The Issue of Discriminatory Behaviour resulting from the lack of a ramp.

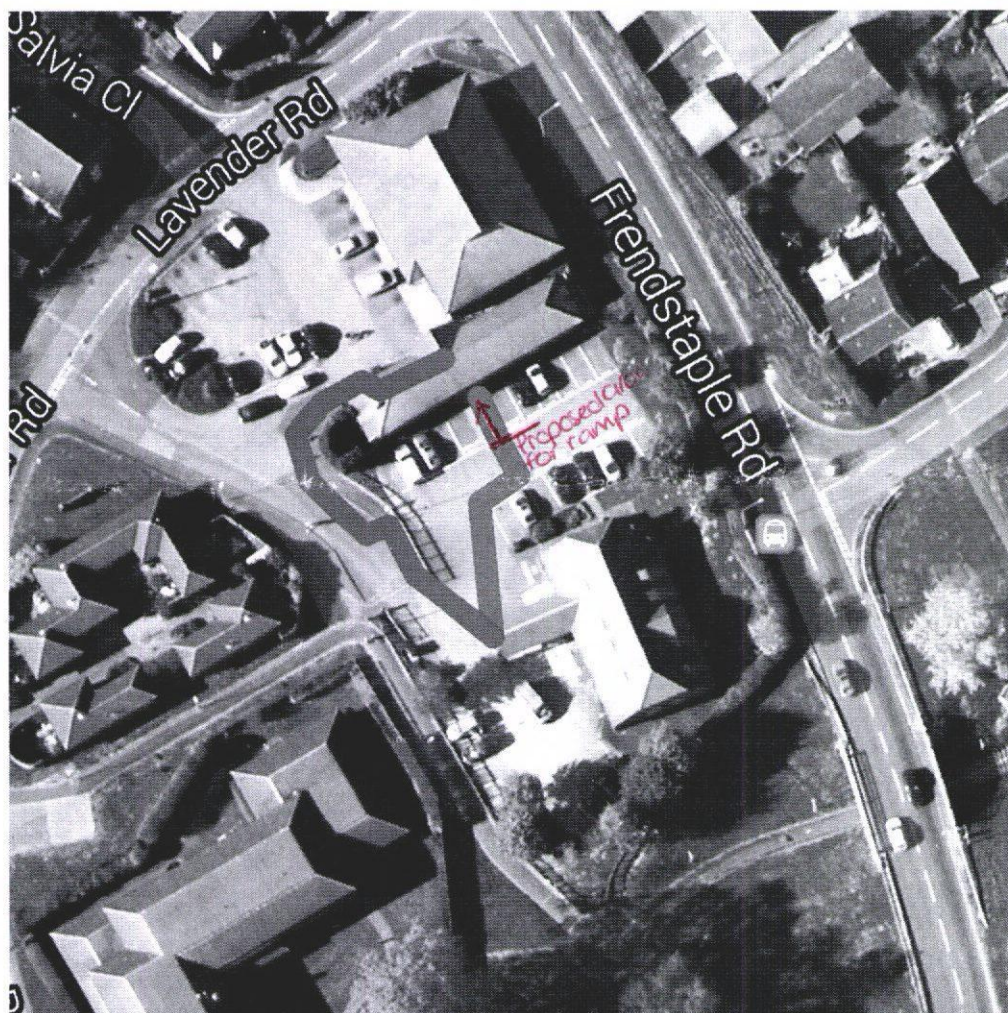
Making use of Google Maps latest incarnation, I've produced this approximate illustration of the difference in routes.

I believe it would be quite clear that the green route represents that which can be taken by able bodied patients, whereas the red route is the shortest option available to those using wheelchairs, scooters, etc. Note the need to leave the pavement and use the road, this is because the pavement does not match with the paving in the complex, and there is no dropped kerb facility to leave the pavement at any other point further along its length. This problem is illustrated clearly in the following photograph:

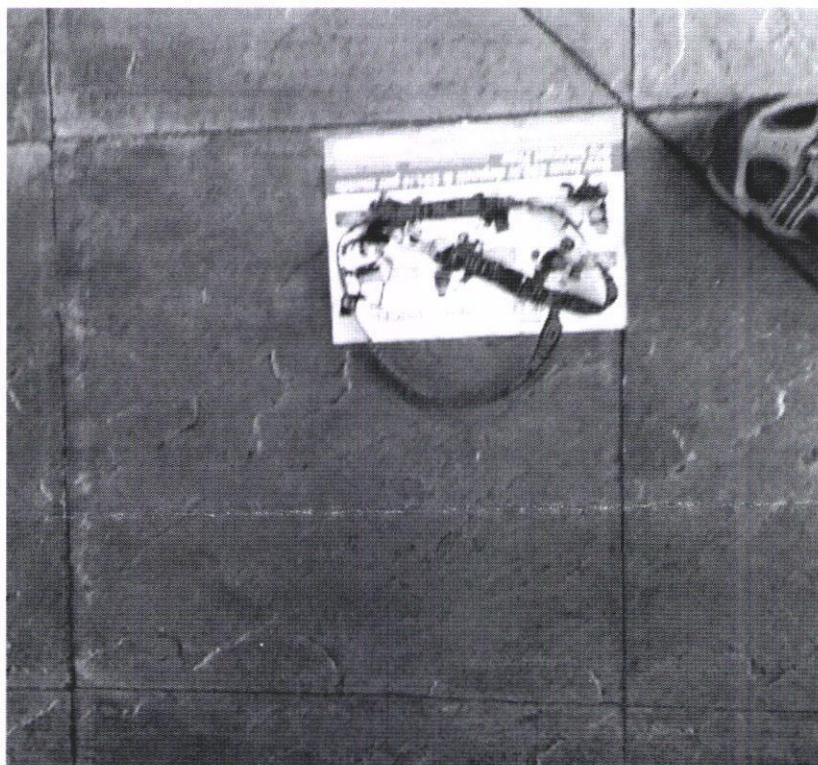
This first photograph shows the step as seen from the perspective of a wheelchair user, from within the shopping complex heading through the gate towards the surgery.

Indeed there is little or no contrast which in itself is a health and safety risk which ought to be considered by those responsible for the entrance as those with limited vision may not appreciate the step is actually there.

This second photograph shows a wider view of the gateway and internal route to the surgery. The windows to the left are part of the pharmacy, and to the right are part of the Chinese Take-Away.

Looking out, we see a long pier which marks a pedestrian route, distinct from the car park itself, reaching part-way to the surgery building, and finally the step itself. Interestingly, when I measured the height of the step, it was only 17cm approximately, which equates to 6.7" high, which for the sake of later discussion we shall round up to 7 inches.
